**SUBJECT:** Calvert Cliffs Nuclear Power Plant  
Unit No. 2; Docket No. 50-318  
Response to Preliminary Accident Sequence Precursor (ASP) Analysis for the  
Unit 2 January 2004 Operational Event

Attachment: (1) Preliminary Accident Sequence Precursor Analysis Comments

### PRELIMINARY ACCIDENT SEQUENCE PRECURSOR ANALYSIS COMMENTS

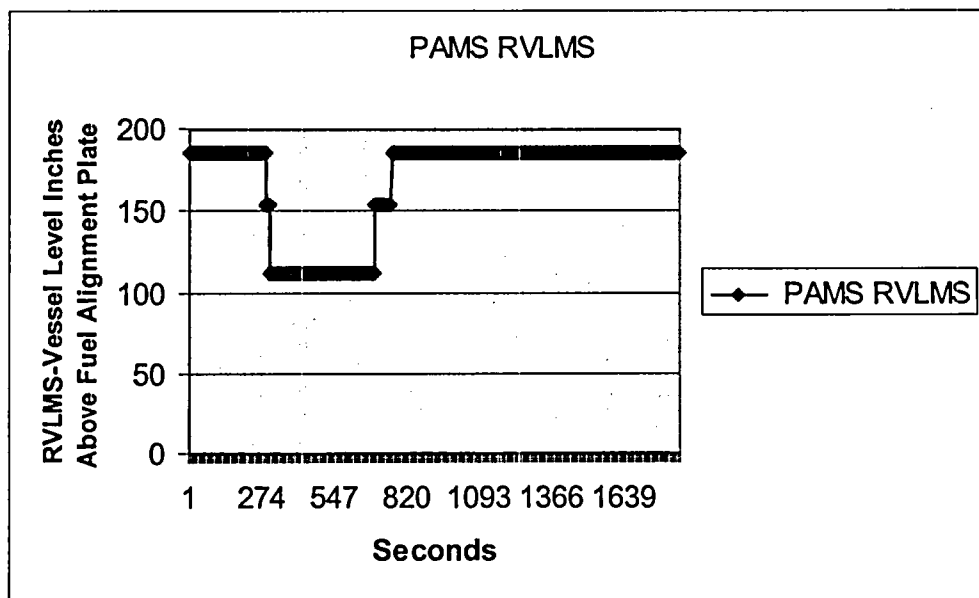
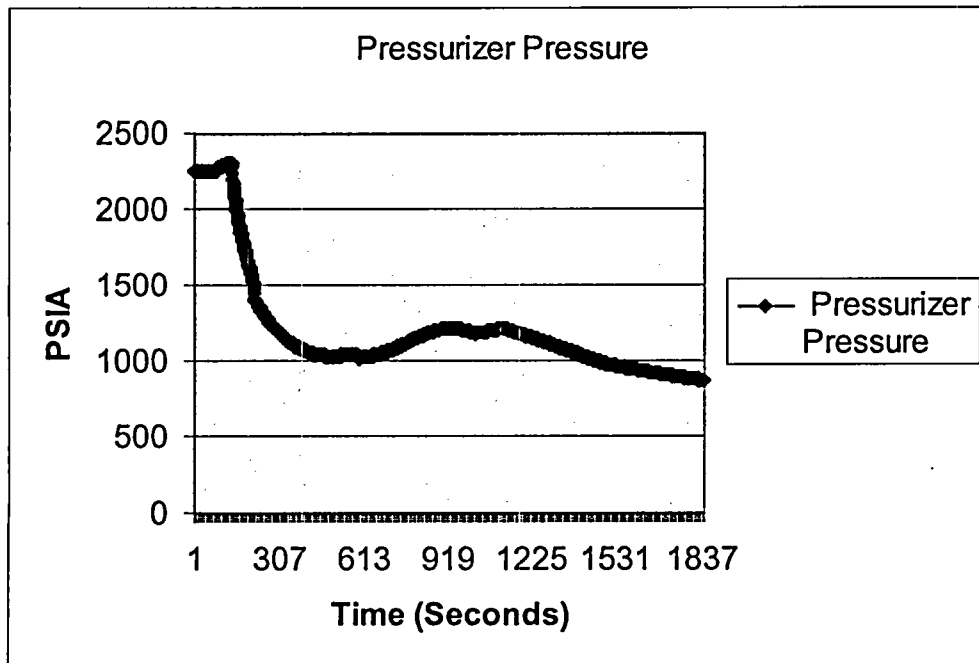
Given this, it is likely that the failure of both MSIVs to close would produce the largest time available to achieve OTCC. Conversely, if both MSIVs closed, this would provide the least time available to achieve OTCC. To determine the time available, the difference between the steam generators reaching -350" and core exit thermocouple (CET) reaching 560°F would have to be determined. The EOP bases state "...Core cooling must be initiated prior to CET temperatures reaching 560°F. This is because the RCS will reach saturated conditions during Once-Through-Cooling at about the temperature it was initiated. Saturation pressure for 560°F is approximately 1133 PSIA. Above this pressure, HPSI flow may not be sufficient for core cooling requirements..."

The RCS pressure prior to OTCC should not be used as the timing basis for OTCC. As can be seen from the EOP basis document, the RCS temperature should be used instead. In general, the lower the RCS pressure is prior to initiation of OTCC, the greater the likelihood that OTCC can be achieved.

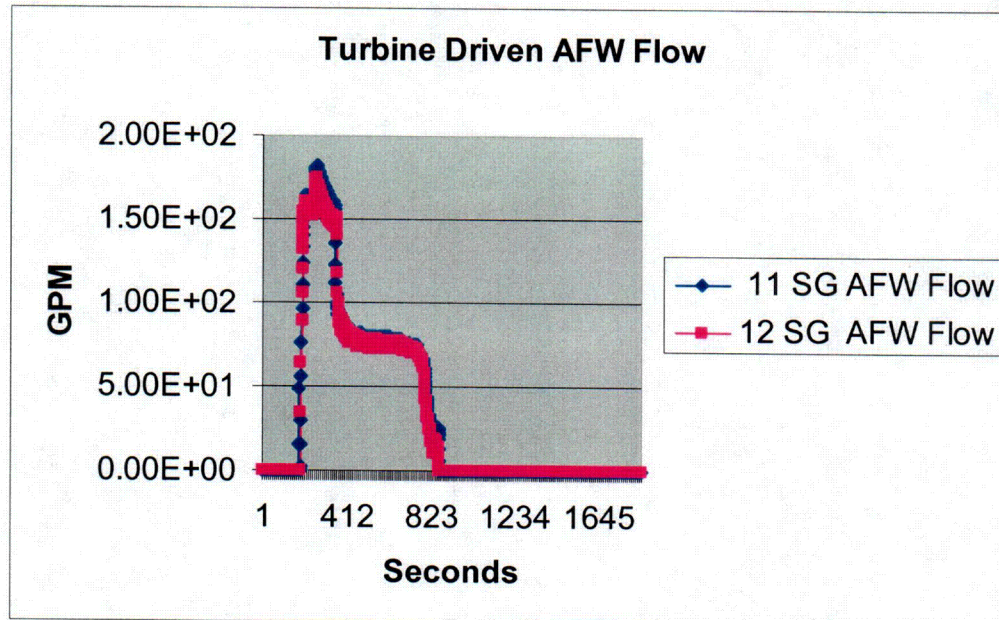
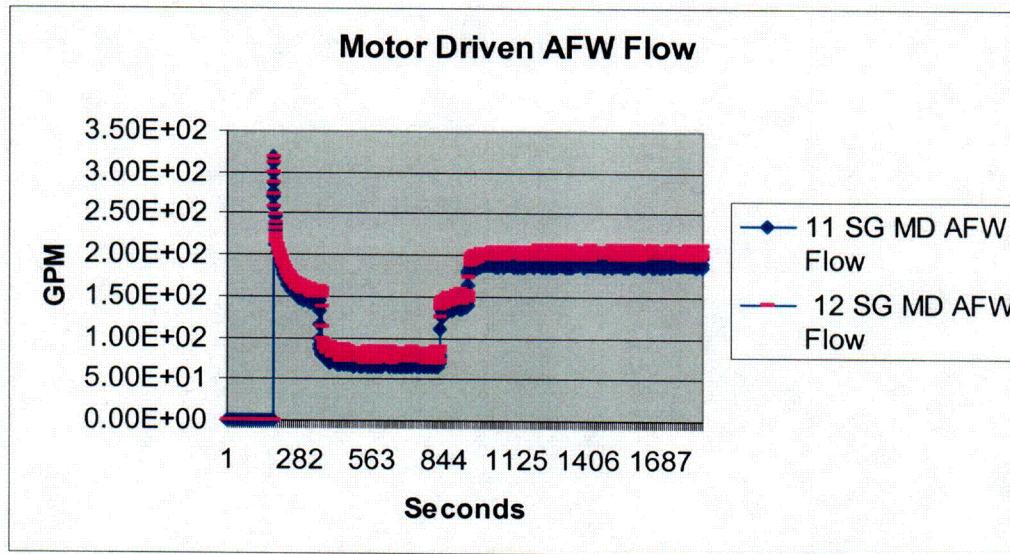
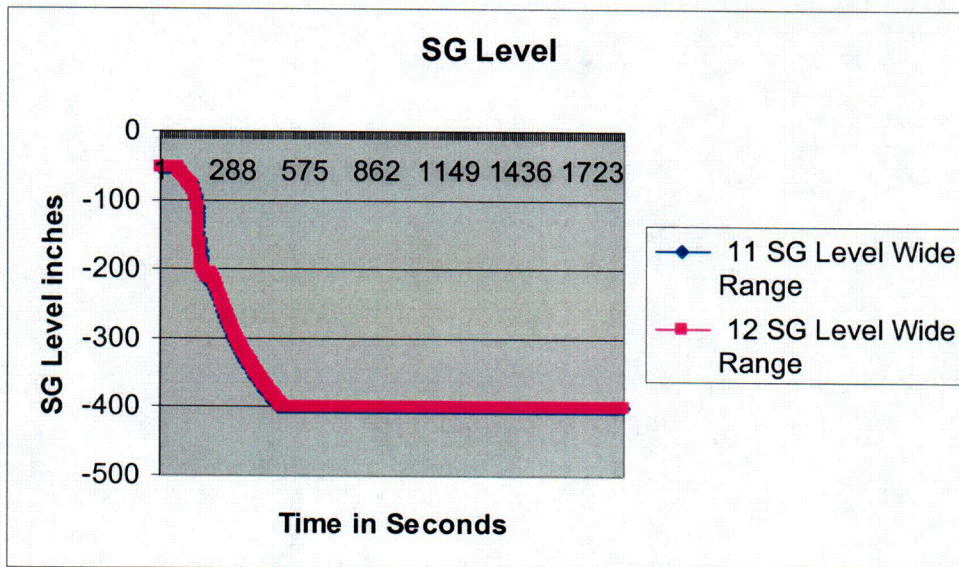
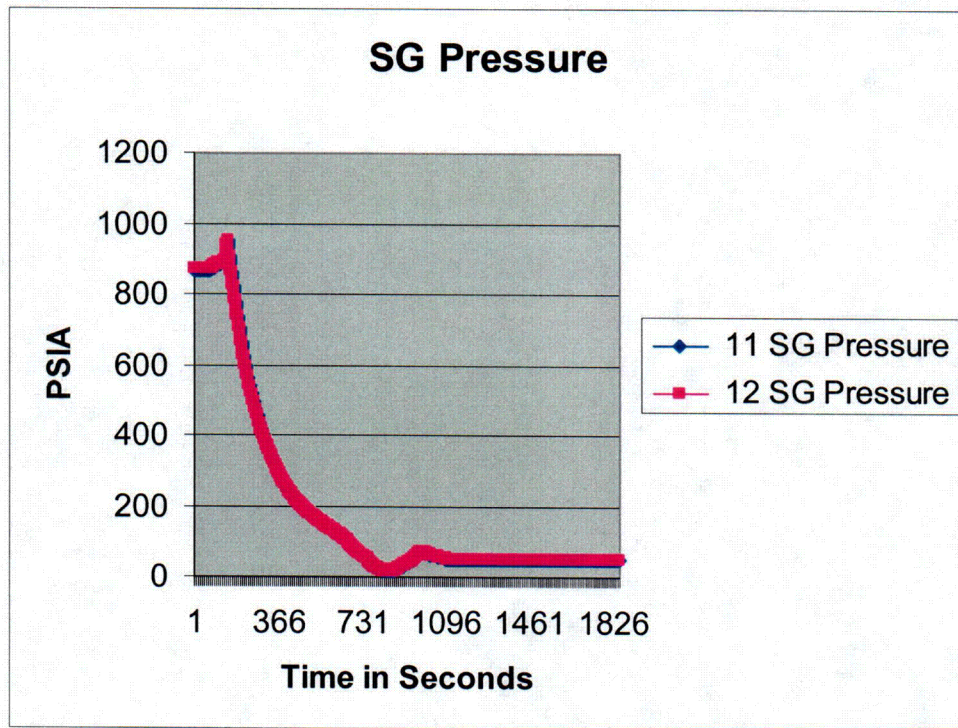
To illustrate the recovery possibilities available, we performed a simulator run with the quick open signal failing to clear AND with the MSIVs failing to close on an SGIS. Probabilistic risk assessment personnel walked through the Emergency Operating Procedures (EOPs) and discussed the operator actions expected in this scenario with Operations training personnel. The relevant graphs are attached. This includes the following parameters:

- Pressurizer Pressure
- Pressurizer Level
- T Cold [Reactor Coolant System (RCS)]
- Steam Generator Level and Pressure
- AFW Flow (Motor- and Steam-Driven)
- Reactor Vessel Level Monitoring System – Vessel Level

3. Significant HPSI flow occurred into the RCS. This is evidenced by pressurizer level increasing at the lower temperatures and by observation of HPSI flow in the simulator. High pressure safety injection flow was not recorded in this simulator run.

4. The reactor core was not uncovered. There was indication of lowering reactor coolant level as observed on the Reactor Vessel Level Monitoring System from the 5 minute to the 12 minute time frame. At the lowest point, there was approximately 7 feet of water above the active fuel.

5. The RCS temperature leveled out above 350 degrees Fahrenheit.
6. Pressure in the RCS leveled out at approximately 1000 psia. Pressure was controlled using operator actions to secure HPSI flow, charging flow, and pressurizer heaters. Auxiliary spray was also used to maintain pressure.

7. Auxiliary feedwater flow, using the motor-driven AFW pump, was maintained during the entire transient after AFAS actuation.
8. Condenser vacuum was lost approximately 12 to 15 minutes into the transient. This is based on an assumed time for the condenser air removal units to fail on loss of Service Water (due to SIAS actuation). Note that for purposes of simulation the TBVs remained open.
